Docket Number:	20-MISC-01
Project Title:	2020 Miscellaneous Proceedings.
TN #:	244209
Document Title:	California Energy Storage Alliance (CESA) Comments on Proposed Final Scenarios to Assess Role of LDES Workshop
Description:	N/A
Filer:	System
Organization:	California Energy Storage Alliance (CESA)
Submitter Role:	Public
Submission Date:	7/26/2022 4:43:05 PM
Docketed Date:	7/26/2022

CESA's Comments on Proposed Final Scenarios to Assess Role of LDES Workshop

Subject: CESA's Comments regarding the Public Workshop on the Proposed Final Scenarios to Assess the Role of Long Duration Storage

Figure 1. DOE Pathways to 5 cent/kWh LCOS²

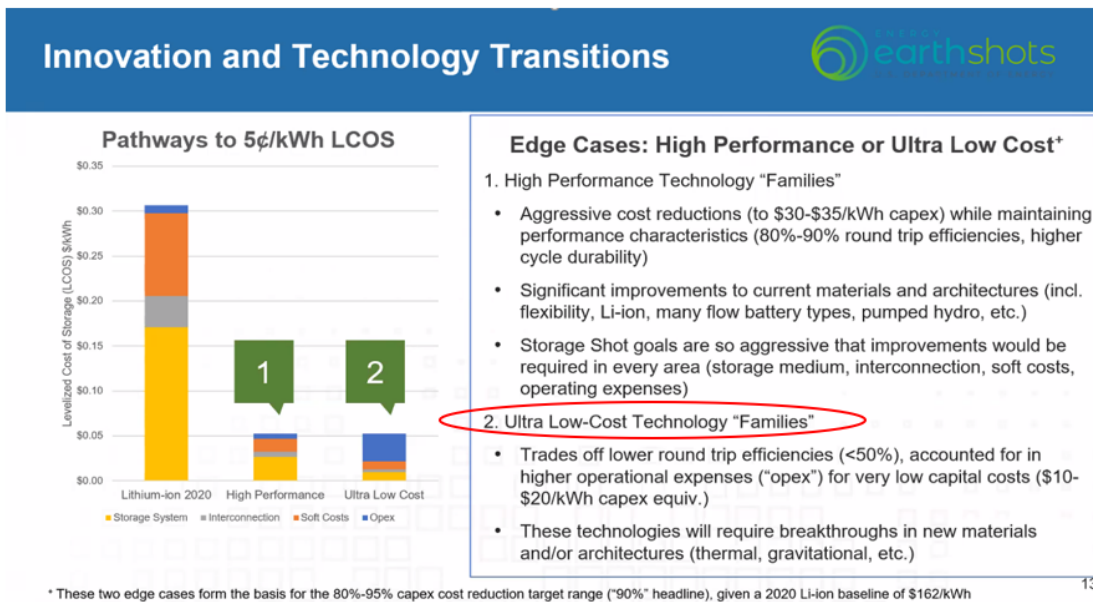
In the Workshop materials, UC Merced focused on explaining the proposed approach using two variable-cost LDES candidate resources: an 8-hour asset with an 81% RTE, and a 12-hour resource with the same RTE. While the use of that RTE might have been for illustrative purposes only, CESA recommends that the variable-cost LDES candidate resources included in UC Merced’s final scenarios consider a wider range of RTE values. Specifically, CESA recommends modeling RTEs across the 35%-85% range, as this better represents the diversity and heterogeneity of existing and emerging LDES technologies. This expanded consideration of RTE would be consistent with the perspective of the Department of Energy (“DOE”) in their Earthshots initiative. DOE has shown that there are two pathways to achieving the 5 cent/kWh leveled cost of storage (“LCOS”) goal. The first is the well-established high-cost and high-performance family of lithium-ion batteries, while the second is the ultra-low-cost family, with much lower capital cost and RTEs. While these are different, either can successfully achieve the LCOS goal as noted by DOE in Figure 1. As such, *ad minimum*, UC Merced should consider RTEs of 35%, 50%, 70%, and 85%; although modeling more points within said range would be desirable.
